LANDSCAPE AND VISUAL REBUTTAL

**OF BRIAN JOHN DENNEY BA (HONS), DIPLA, FLI, CENV,
MIEMA**

**AN OUTLINE PLANNING APPLICATION FOR THE
ERECTION OF UP TO 85 RESIDENTIAL DWELLINGS
(*REDUCED FROM 93 ORIGINALLY*) AND OPEN SPACE
(17/04673/OUT)**

**LAND AT JUNCTION WITH CARR ROAD, HOLLIN BUSK
LANE, SHEFFIELD, S36 1GH**

Photo 1 - looking North from Huntshelf Bank, the site is located centrally, visually contiguous with the adjacent Green Belt land. The Peak District sits in the background

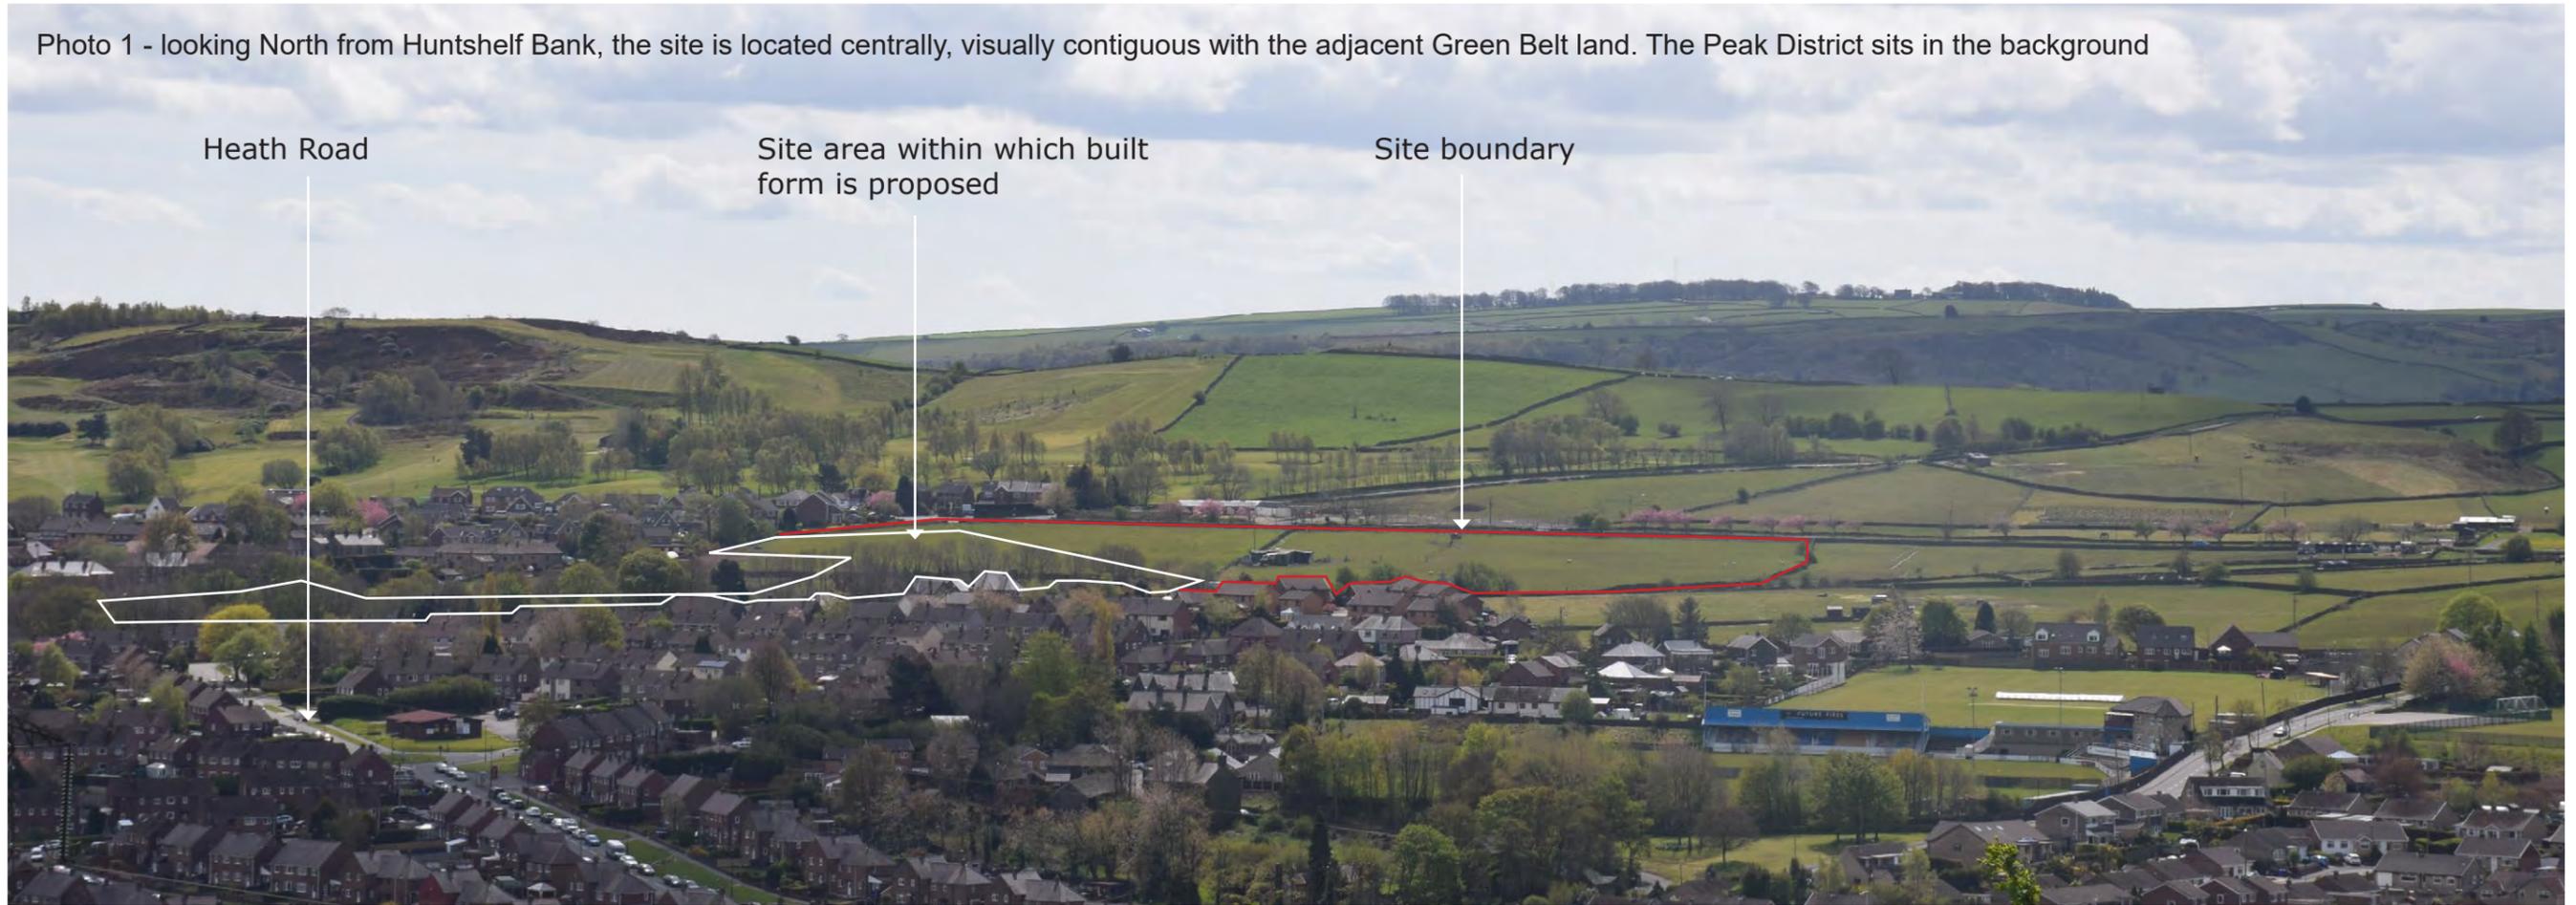
- *Photo 1* – I provide the extent of proposed built development.
 - *Photo 2* – I provide annotations which identify that the part of the site across which the view extends, is in fact those areas proposed to be partly free of built development which include the Public Open Space and the western field within which ecological and biodiversity improvements are proposed. The areas proposed for built development extend to the right-hand side of the view. In referencing this view within his Proof of Evidence, Mr Ares does not acknowledge that there are also settlement areas both within the view and immediately adjacent to the viewpoint. Indeed there are properties further up the hillside behind the viewer and all the way down Carr Road. Mr Ares also states at his paragraph 3.8, that '*when viewed from the south and east (along Hollin Busk Lane) it is not possible to discern the main built form of Stocksbridge from the areas to the north or the east of the site*'. It should be noted, that, as shown within Mr Ares' Photograph 2, settlement is visible to the western end of Hollin Busk Lane as well as further north and this is an important element of the landscape/townscape character when travelling from east to west along Hollin Busk Lane, as set out at Table A3.1 (CD6.18, Appendix 3).

Above is Mr Ares' Photo 1, to which I have added three annotations and a white outline of the area of proposed built form.

VIEW S1

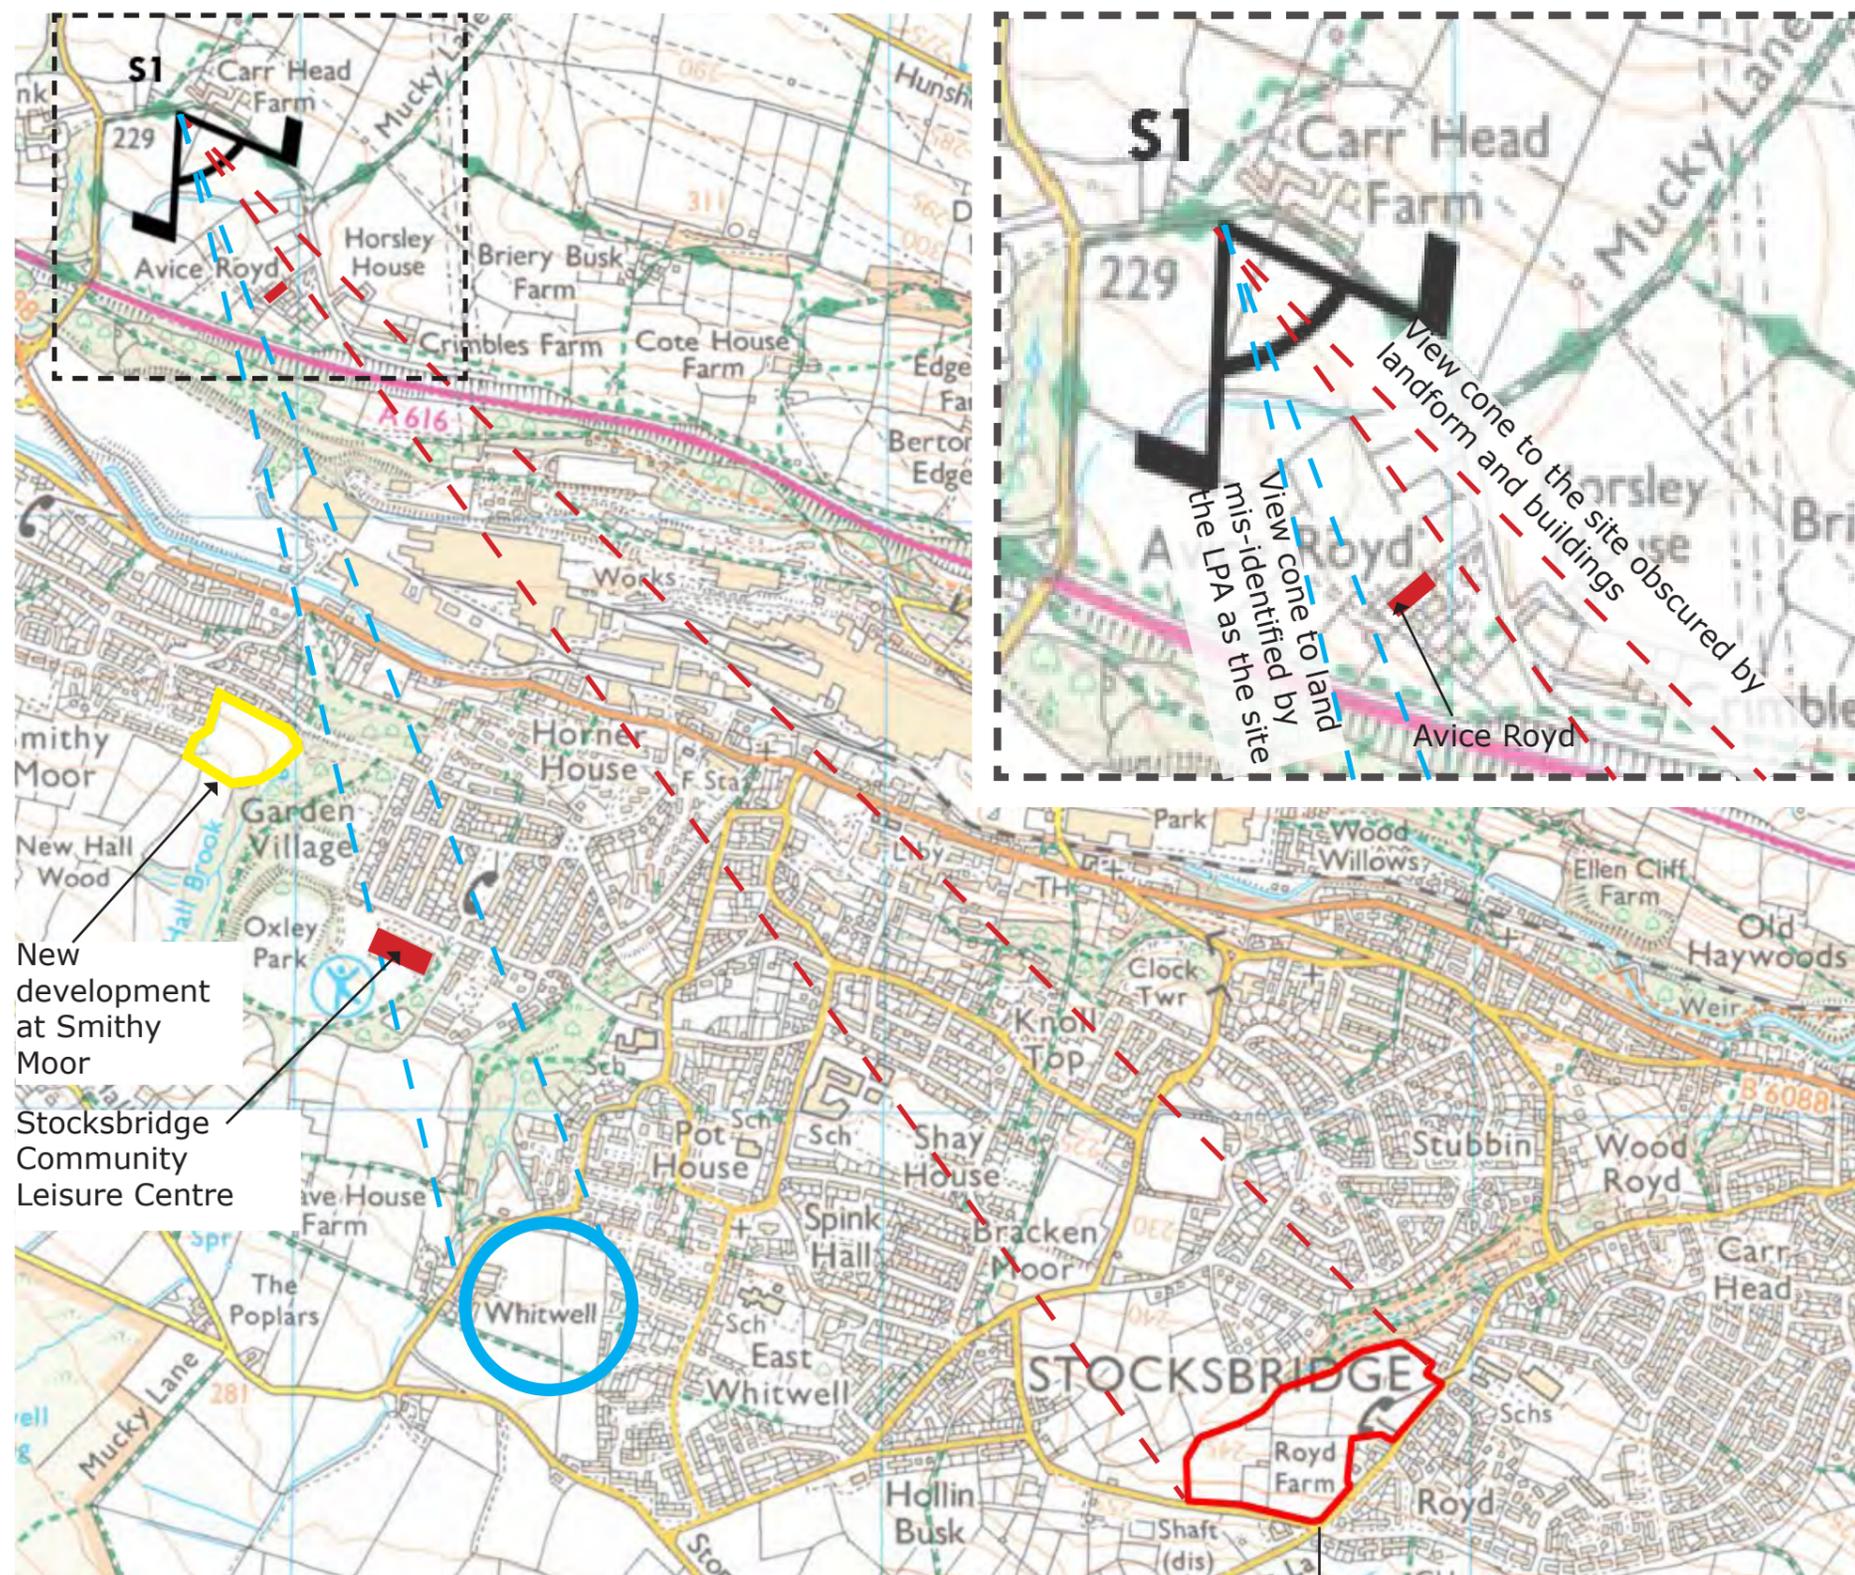
- Mr Ares describes at his paragraph 6.49, that clear views '*extend as far as Carr Head Farm (Photo S1)*'. This is not the case and Mr Ares has mis-identified the site within the view available from this location. He has focussed on another site

altogether. Mr Ares has overlooked that the computer-generated Zone of Theoretical Visibility (ZTV) at Figure 8 of the LVA, does not show theoretical visibility at this location. I provide the relevant extract of the ZTV at my Annex 2. I also provide annotated mapping and photography which shows that, by reference to other distinctive elements within the view, the appeal site is indeed, screened from view by the landform upon which the property at Avice Royd is located.

Above is Mr Ares' Photo from his viewpoint S1, to which I have annotated Avice Royd, Stocksbridge Community Centre and new development at Smithy Moor.

Below is Mr Ares' viewpoint location plan, upon which I have annotated Avice Royd, Stocksbridge Community Centre and new development at Smithy Moor. I also add view cones to the appeal site (dashed red lines) and view cones to the land mis-identified as the site by Mr Ares. I provide also, an enlarged extract depicting the view cones in relation to Avice Royd.

Location of viewpoint S1 outwith ZTV

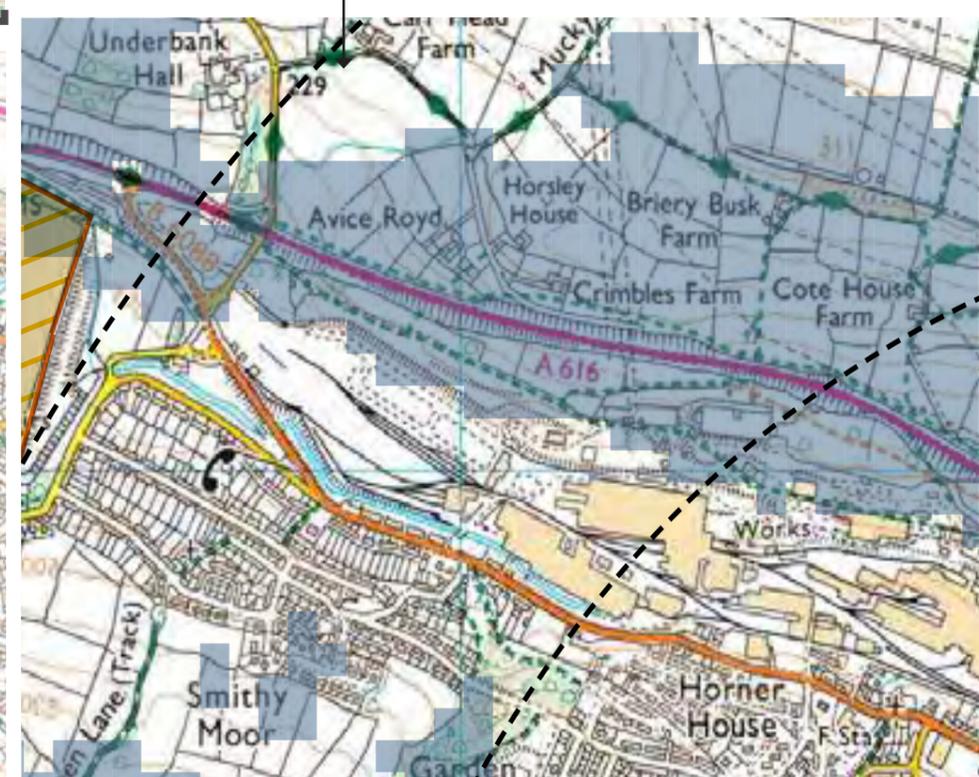
Above is an extract from Appellants ZTV (LVA Figure 8 - Brian Denney Appendix 1) showing the screening effect of landform upon which Avice Royd is located, upon which I provide an annotation of the location of Mr Ares' viewpoint S1.

VIEW S2

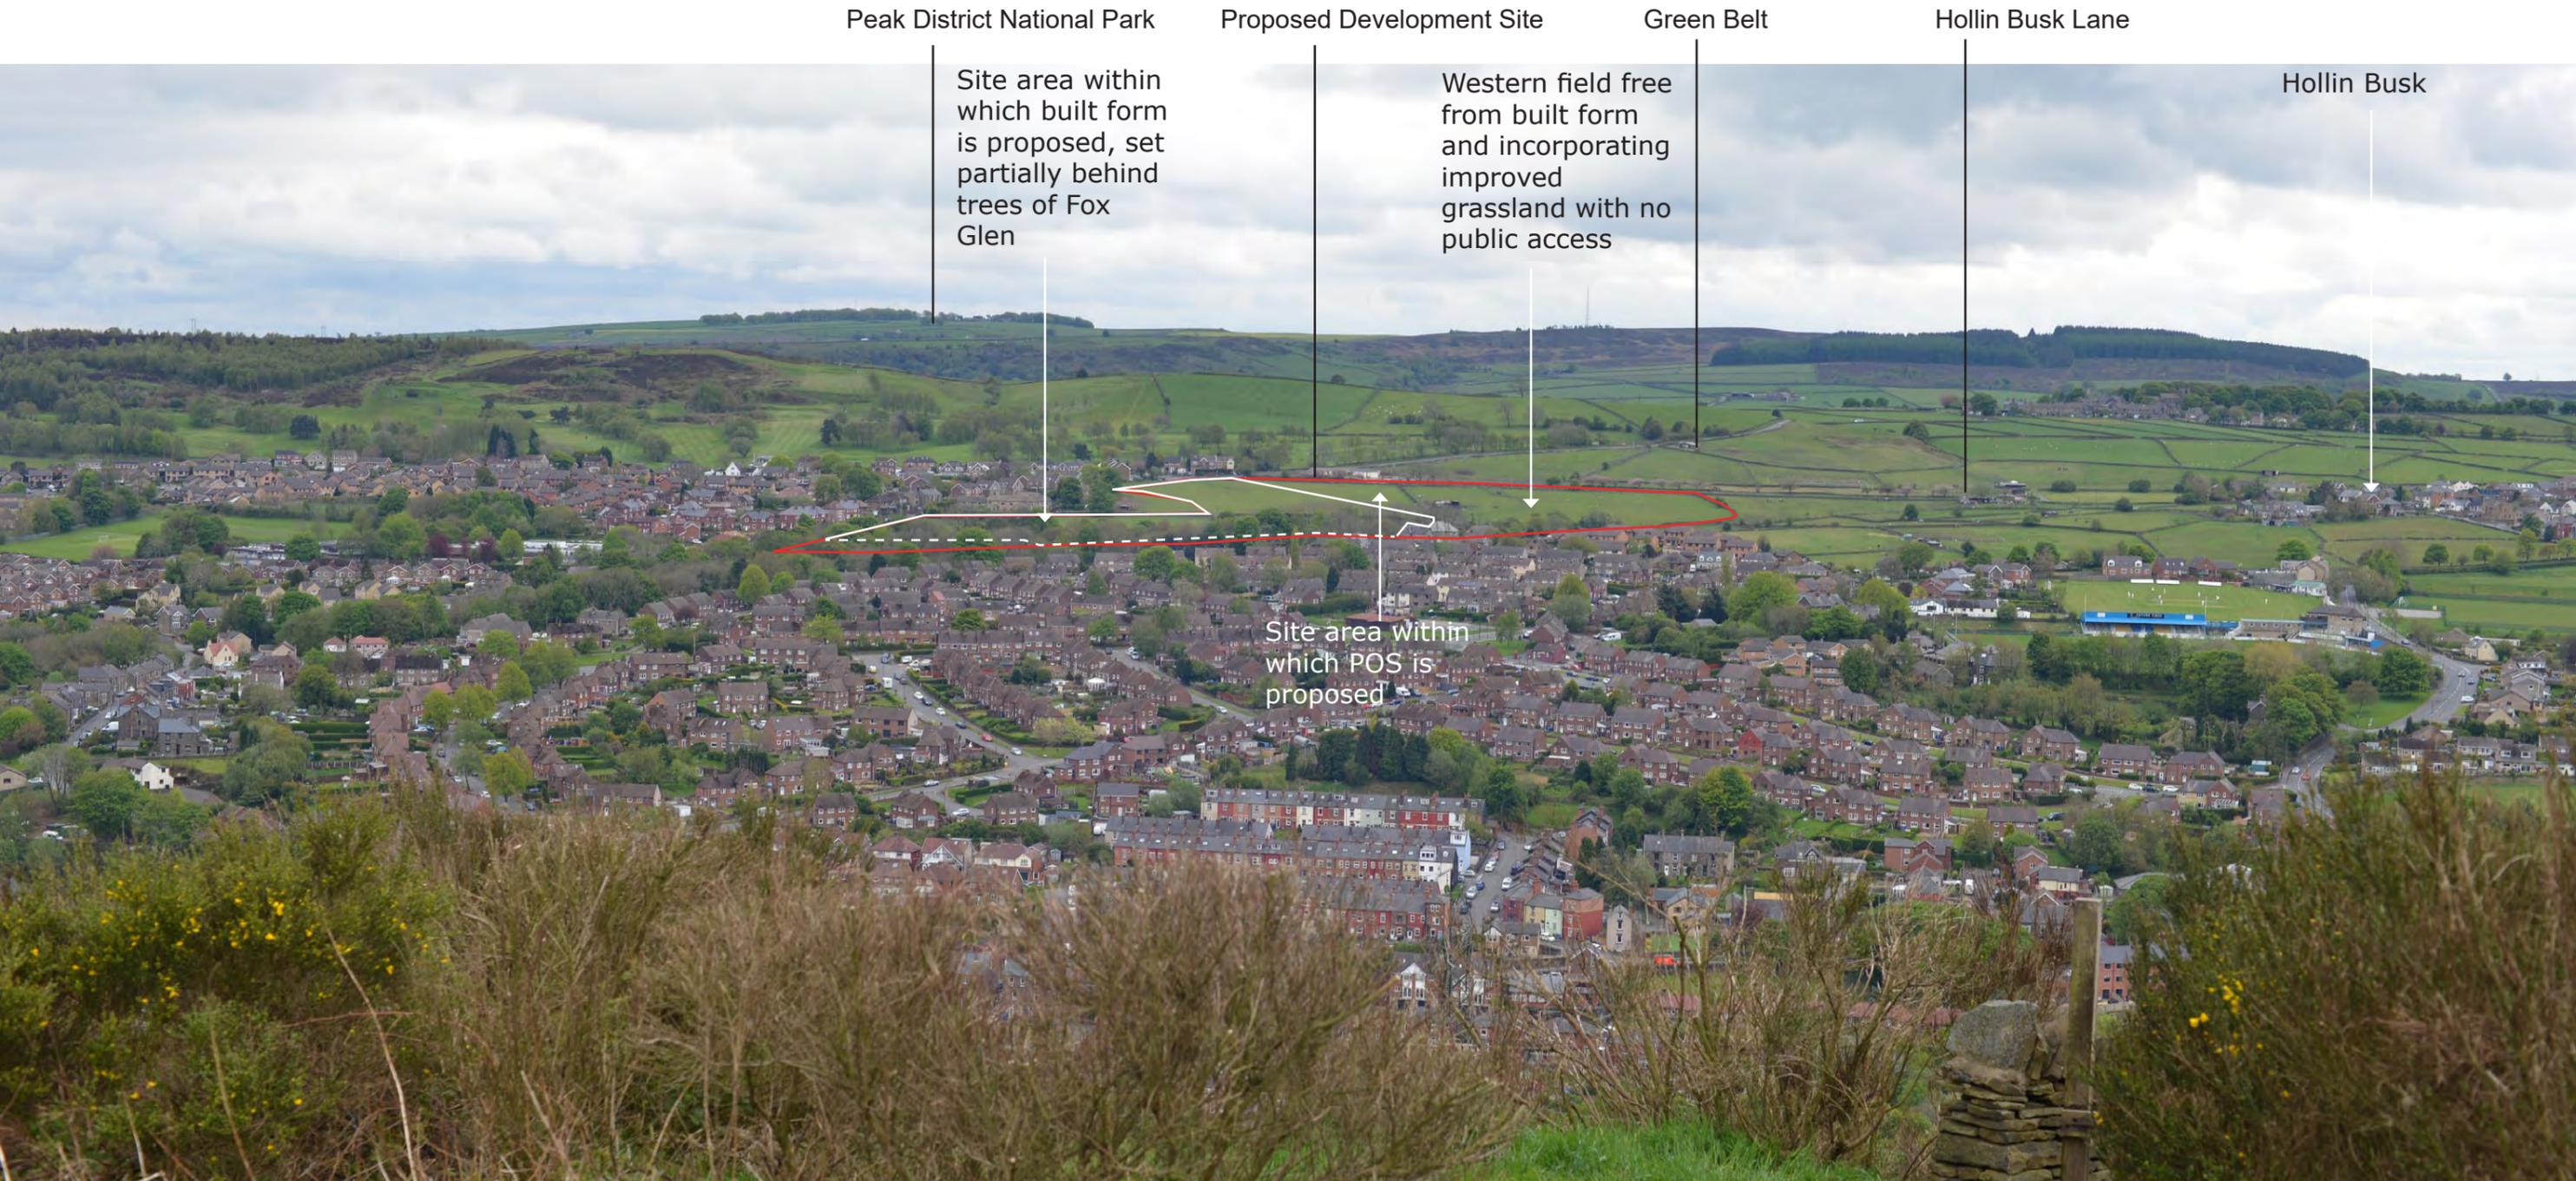
Above is Mr Ares' Photo from his viewpoint S2, to which I have added four annotations and a white outline of the area of proposed built form (dashed where set behind trees).

My photo from Mr Ares' viewpoint S2 with my annotations and a white outline of the area of proposed built form (dashed where set behind trees).
